Town Council Agenda Meeting

a. AR-04-23 Creston Commons

To: Reagan Parsons, Town Manager
From: Alaina Mallette, Senior Planner
Subject: AR-04-23, Creston Commons, 555 Talmadge Way
Date: May 9, 2023

Building Type I - Phase II Front/Rear Elevations

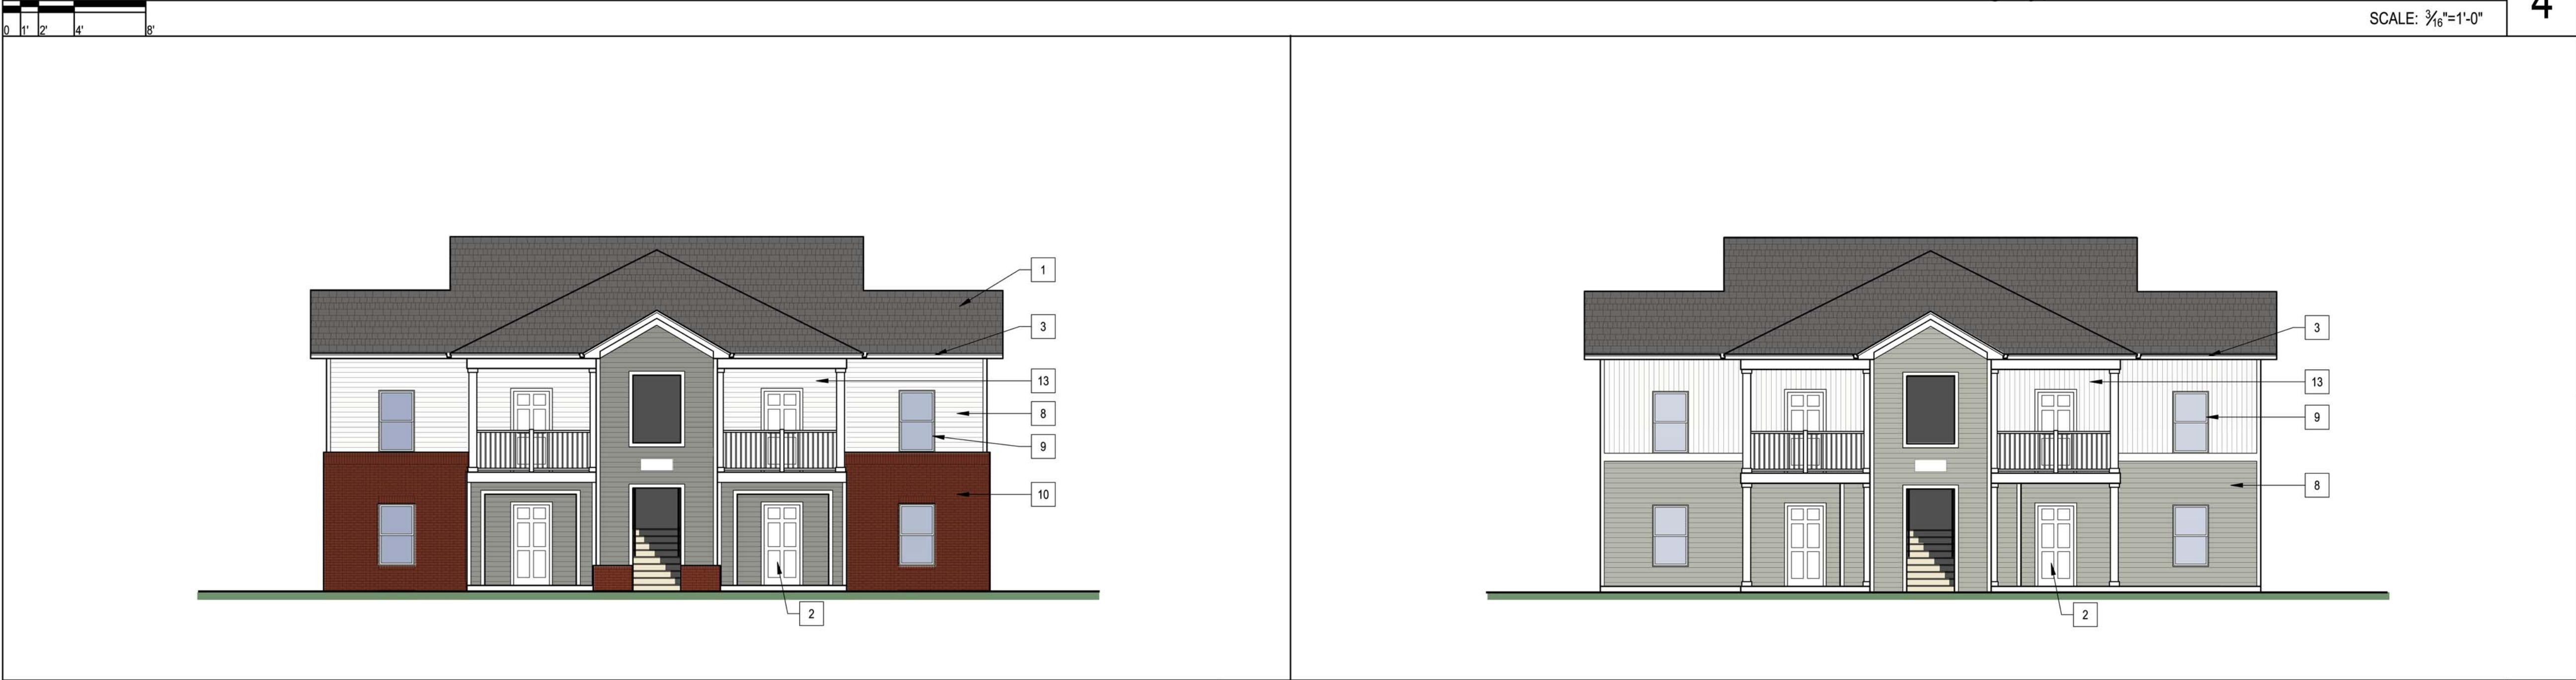
- ✗ The applicants are proposing replacing the existing vinyl siding from 8 multifamily buildings and 1 clubhouse with fiber, cement lap siding (i.e., “Hardie plank siding”). The applicants are requesting a deviation on the basis that the Hardie plank siding is greater in durability to vinyl siding and that brick is too cost prohibitive. Note that the existing brick will not be removed or replaced. No calculations were provided for building materials. The Town Council may consider approving:

- Regarding UDO §4.10.4 (C) Building Materials, the Planning Department recommends granting the deviation, since the Hardie plank siding is an alternative building material that has equal durability to what is required, satisfies minimum building code standards, and exterior walls are screened from public streets, walkways, and residential districts.
